**TP3606 NUT (6-40 HEX.), TP124177 LOCKWASHER,
TP311516 POST, AND TP193755 COVER**

APPARATUS AFFECTED: 35A Typing Reperforator Unit; 35A and 35B Tape Typing Units; TP193755 Magnet Coil Cover.

OBJECT: To prevent possible loosening of the print suppression magnet assembly.

Fig. 1

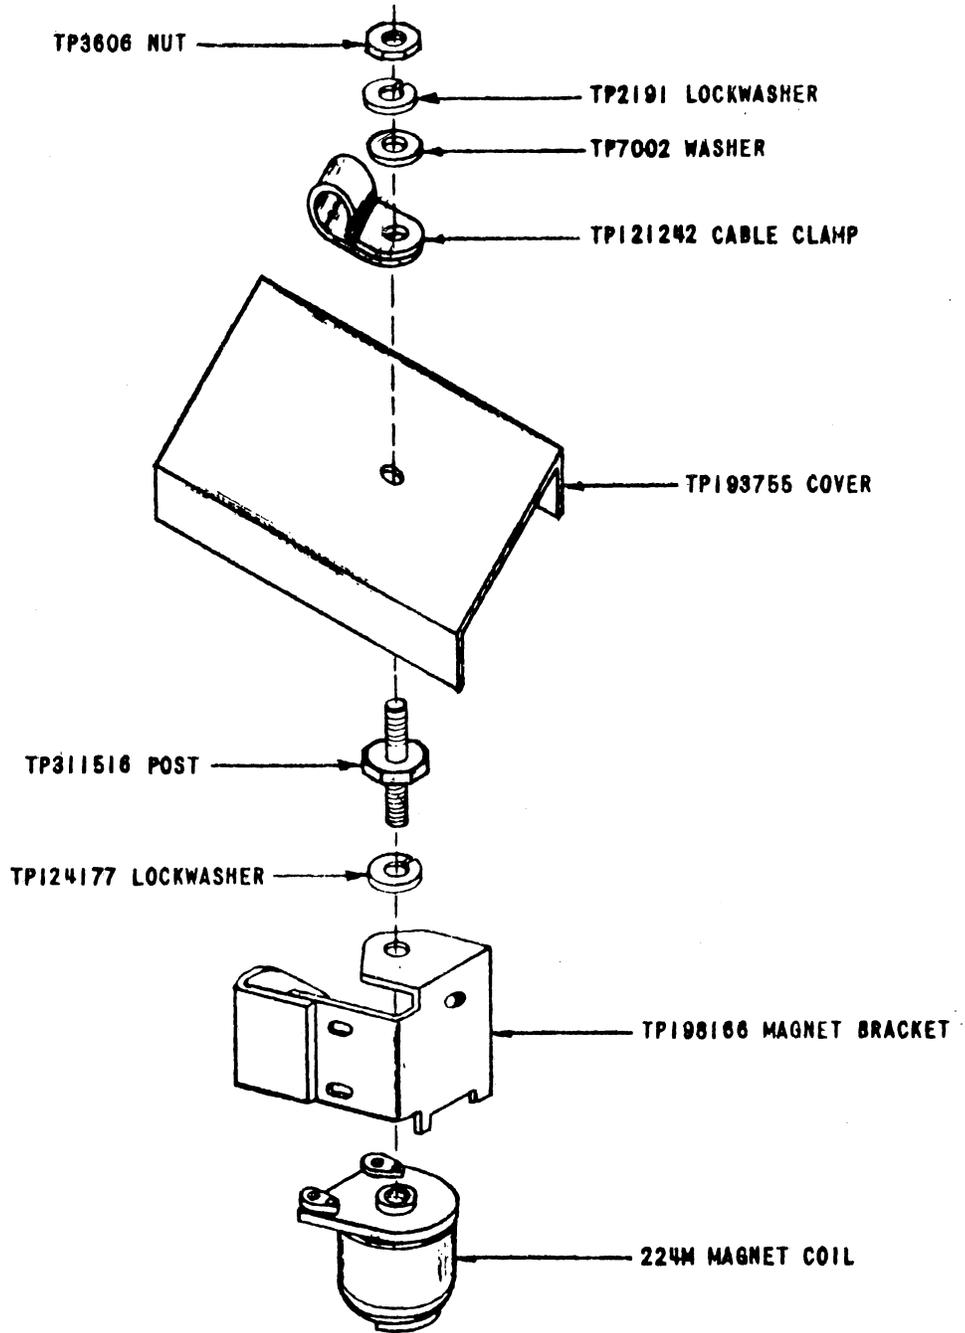
CHANGE: The following changes have been made on the ribbon shift mechanism: (a) The TP93380 flat washer and TP151442 (6-40 by 1/2" hex.) or TP153839 screw (6-40 by 5/8" hex.) have been removed. The TP311516 post, TP124177 lockwasher and TP3606 nut (6-40 hex.) have been added. (b) The 0.125-inch diameter (tie point) hole on the TP193755 cover has been deleted.
